October 29, 2019

RE: Headrick Garage and Pool Addition Watercourse Classification Memo - CAO19-014

Figure 1: Contributing Basin to Stream A

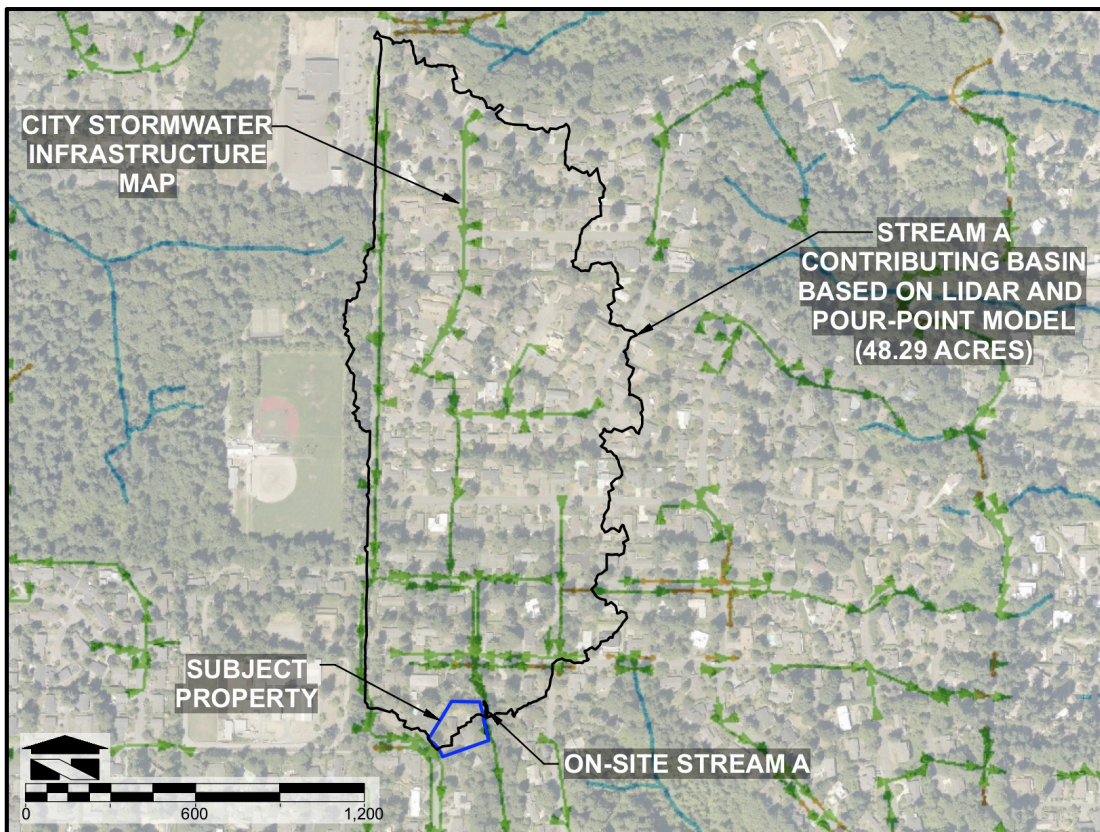
The WDNR maps are tool to make this determination initially; however, in the areas outside of commercial forest production districts, the maps were not developed with field data. Therefore, anyone using the WAC and maps needs to actually collect stream data to demonstrate if the physical criteria from above are met for presumed fish use. Part of this determination means determining if there are any natural barriers downstream. We are unaware of any such barriers but the City may data otherwise. If there are no known natural barriers, then stream data for bankfull width and streambed gradient needs to be collected by measuring 6-10 random samples on site and compare against the physical criteria. If it is met, the Stream is a Type 3/Type F fish bearing water based on presumed use.

Stream A discharges to an 18" PVC culvert in approximately the southeast corner of the property. Based on comparison with the City's stormwater inventory, and by constructing a pour-point model using publicly available LIDAR data, the contributing basin to the on-site portion of Stream A is 48.29 acres in total area.

Figure 2: Existing Site Conditions and Channel Measurement Location

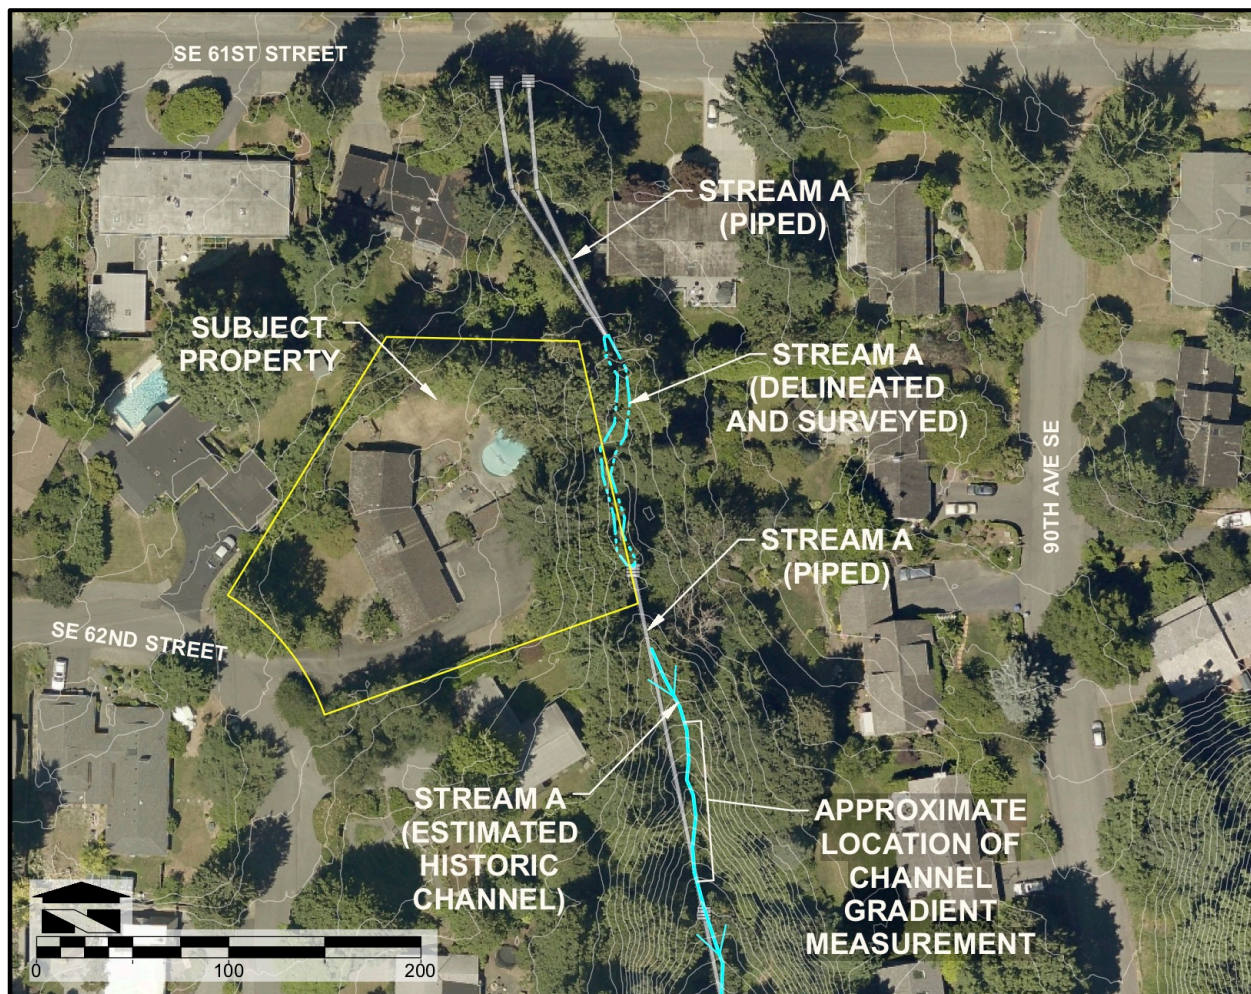
From a review of the site plan map showing the locations of the surveyed OHWM, it appears that the stream meets the criteria for bankfull width (i.e. >+2 feet). The streambed gradient is unknown at this time. More data is needed to establish the streams classification.

Using a Suunto clinometer, surveyor’s rod (long fiberglass pole), and a 100-foot measuring tape, WRI staff conducted a channel gradient measurement in the field. This area was selected for field measurement based on a WRI analysis of elevation contours generated from publicly available LIDAR data that indicated a continuous slope exceeding 20 percent gradient for at least 88 horizontal feet. Due to the presence of dense, sight-obscuring vegetation, and limited site access, channel gradient was measured in two segments. The first segment was 55 feet in length (parallel to the sloping ground surface) and began at the lowest point of the historic channel. The second segment was 35 feet in length along the ground surface. Each segment was measured using the following method.

Each segment, as measured in the field, showed a slope angle of 21 degrees. Using basic trigonometry, it was determined that the horizontal distance of the first segment (55 feet along a 21° slope) equals 51.3 feet, and that the horizontal distance of the second segment (35 feet along a 21° slope) equals 32.7 feet. Therefore, a continuous 21° slope was physically observed for a total horizontal distance of 84 feet. Farther downstream of the measurement location, channel gradient appeared to become less steep. Above the upstream limits of measurement, slope appeared to be as steep or steeper than the measured segments. Based on the total area of the contributing basin (48.29 acres), and the observed 21° slope, the on-site portion of Stream A does not meet any of the presumption-of-fish thresholds established in the WAC. Stream A is correctly classified as a Type III/Type Ns watercourse in the vicinity of the subject property.
